FINAL CLOSURE RESULTS AND REPORTS

SKF ROLLER BEARINGS DIVISION

REFERENCE: SKF CLOSURE PLAN AND STUDY OF GROUNDWATER CONTAMINATION
SHIPPENSBURG FACILITY - I.D. NO. PAD 003026606 FRANKLIN COUNTY

ADDENDUM TO THE
OCTOBER 1984
GROUND WATER STUDY

PREPARED BY: T.A. HILL CLIENT: SKF INDUSTRIES
 CHECKED BY: _____ PROJECT NO.: _____
 DATE: 10/4/85 REV: 1 SHEET: 1 OF 1
 SUBJECT: LOCATION OF SOIL SAMPLES TAKEN BY LANCY INT. AT SKF IND., SHIPPENSBURG, PA.

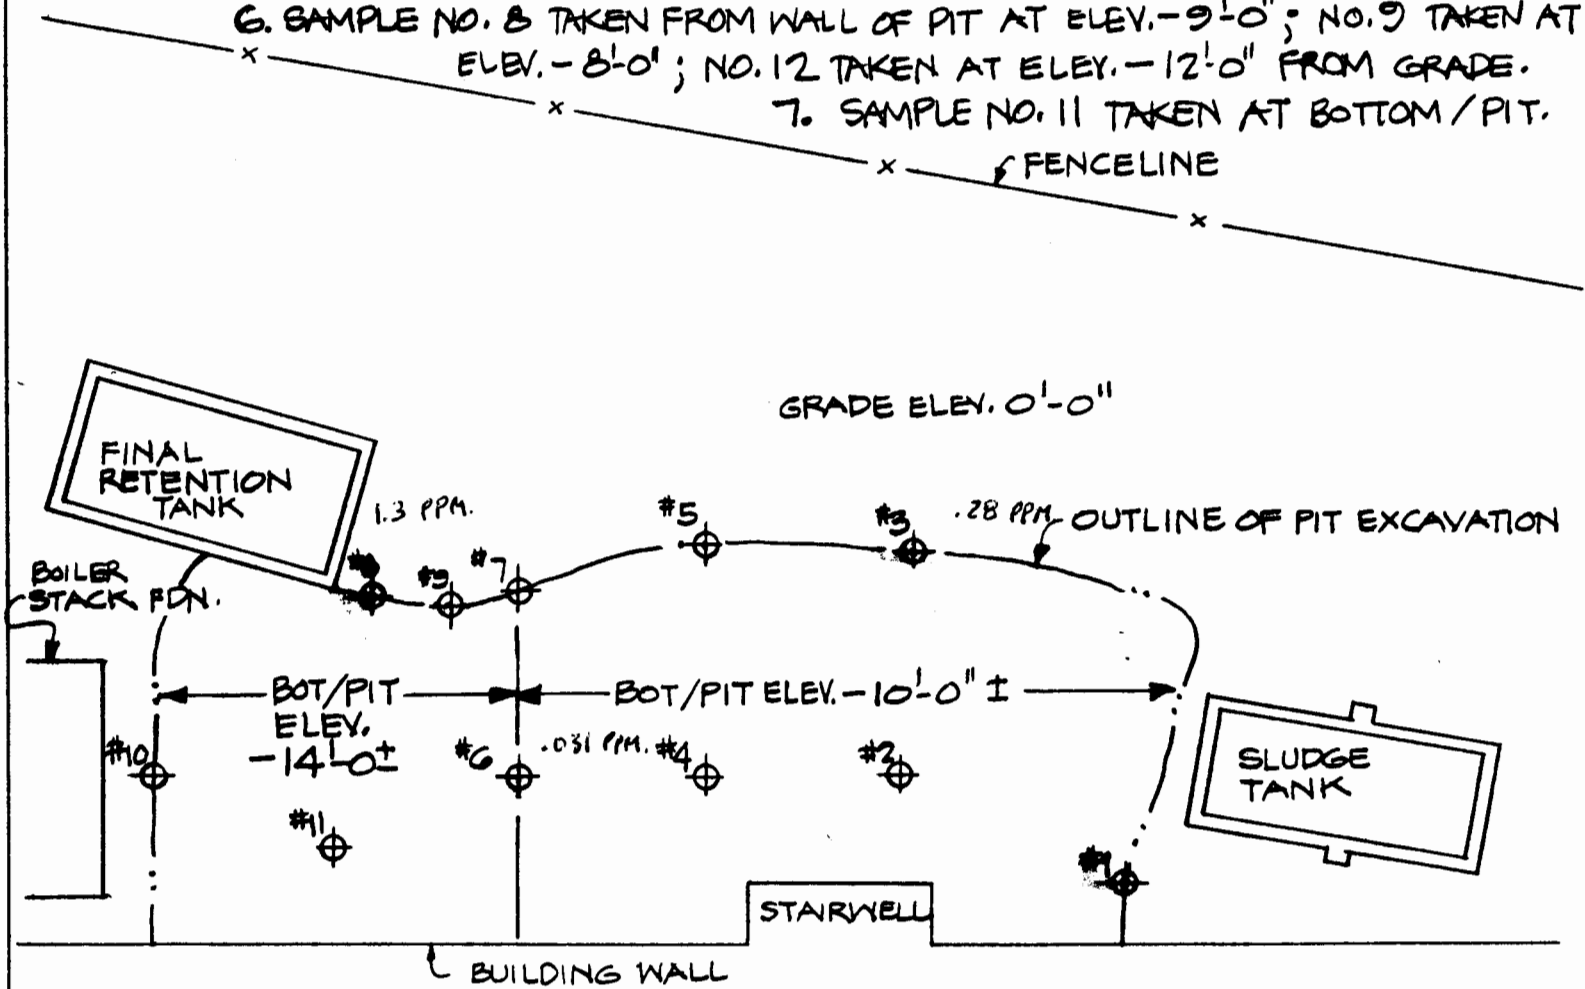
REMARKS FRANK, PLEASE REVIEW THE ATTACH. SKETCH SHOWING THE LOCATIONS OF SOIL SAMPLES TAKEN FOR THE CLOSURE PLAN. I SUGGEST WE ANALYZE SAMPLE NOS. 3, 6, 8 TO COMPLETE THE FOUR SAMPLE ANALYSES CALLED FOR IN THE PLAN. PLEASE LET ME KNOW YOUR THOUGHTS. THANKS.

TIM/10-15-85 - I THINK THIS IS A SATISFACTORY
APPROACH TO FINALIZE CLOSURE.
